# LIGO-T1100486-v1

In order to protect the LT1021-5s on the Trillium Pressure board, we should install a bidirectional transient voltage suppressor (TVS) at the input. The current schematic looks like this:

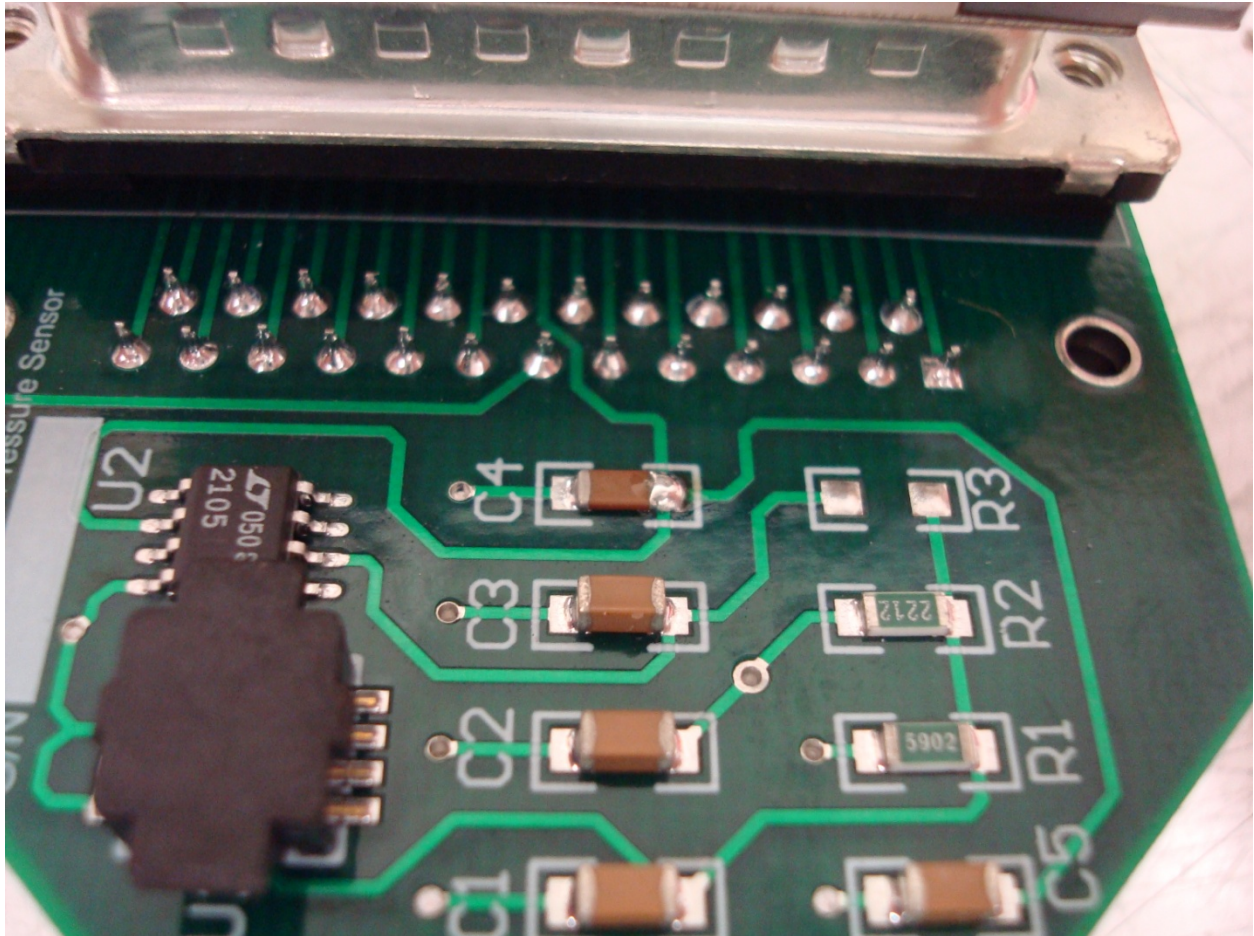
And the voltage we're trying to regulate is labeled +18Vprot, because it is protected from polarity flip by the input diode, D2. That diode doesn't care about input voltage spikes, however, so we should protect against those, as well. The most convenient place to put the TVS is across C4. The whole process, including pictures takes about 1 minute, 20 seconds (the pictures really slowed me down). Here are some pictures of how to go about doing that:

TVS: Digikey P/N SMBJ20CABCT-ND.

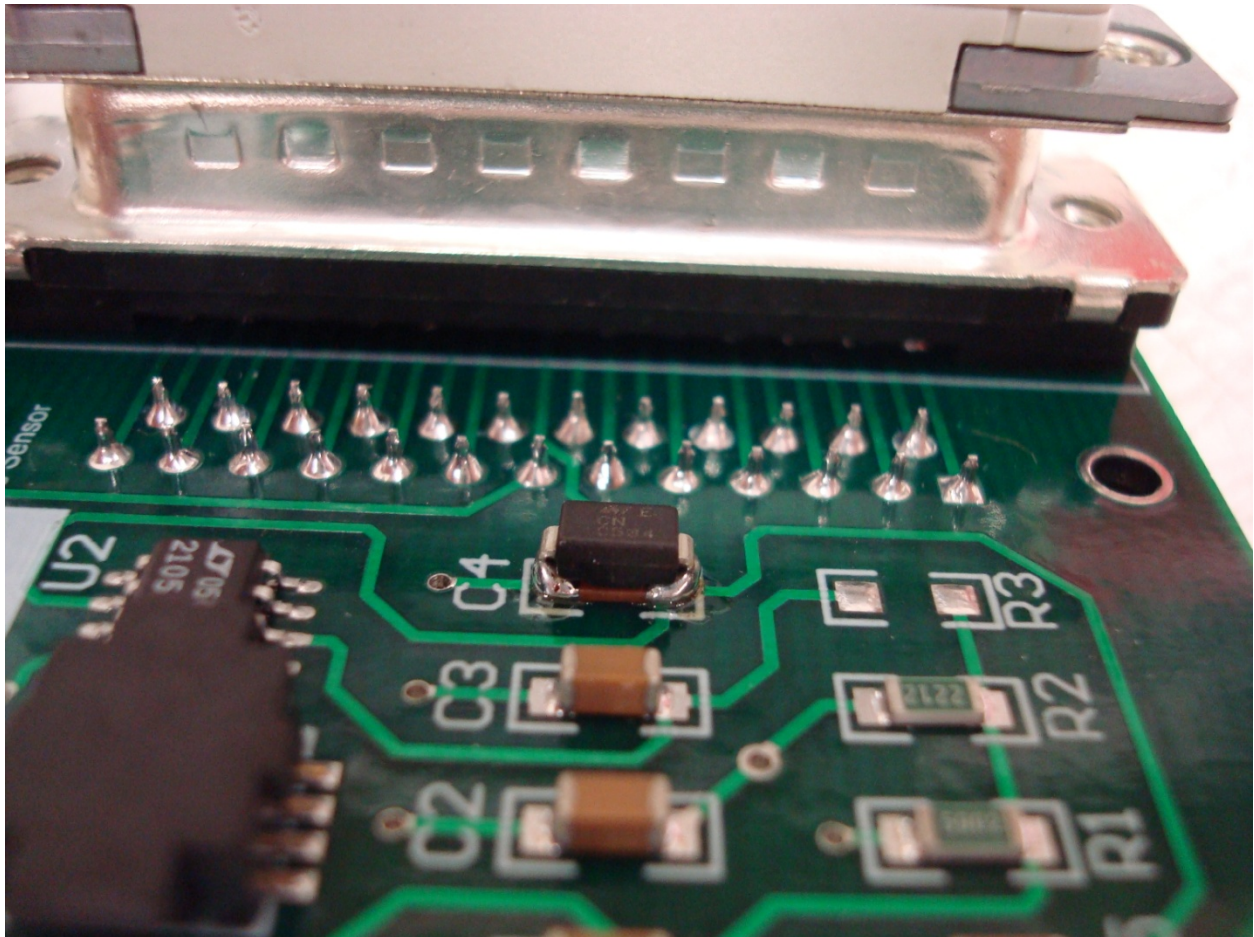
A closeup of C4. Notice that I added extra solder to the right side of C4 in preparation for soldering the TVS on:
